**Report: TAB Report**  
**Function: Test, Adjust, & Balance**  
**Date: 03/19/2025**  
**Completed By: National TAB**

**PROJECT**  
**03-17-25 CAVA TEMECULA, CA (REDHAWK)**

- HOOD SIDE PANELS NOT INSTALLED
- KEF GREASE CUP

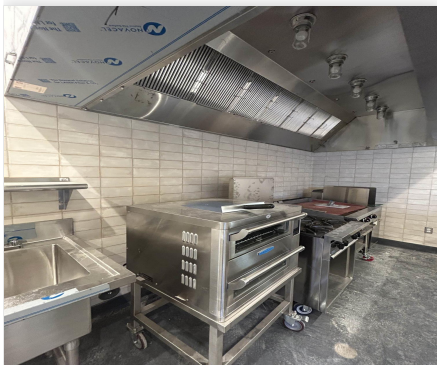
**Issue Name :** HOOD SIDE PANELS NOT INSTALLED  
**Description :** Hood left vertical side panels have not been installed. Recommend installing panels as shown in the MSET.  
**Created By :** National TAB                      **Assigned To :** National TAB - Dan Hertenstein  
**Status :** Open  
**Priority :** Medium                                      **Asset Tag :**  
**Originated Date :** 03/19/2025 - David Nicolas Sanchez - National TAB

**Issue Name :** KEF GREASE CUP  
**Description :** KEF grease cup is not installed. Recommend installing grease cup to prevent grease from dripping on the roof.  
**Created By :** National TAB                      **Assigned To :** National TAB - Dan Hertenstein  
**Status :** Open  
**Priority :** Low                                      **Asset Tag :**  
**Originated Date :** 03/19/2025 - David Nicolas Sanchez - National TAB
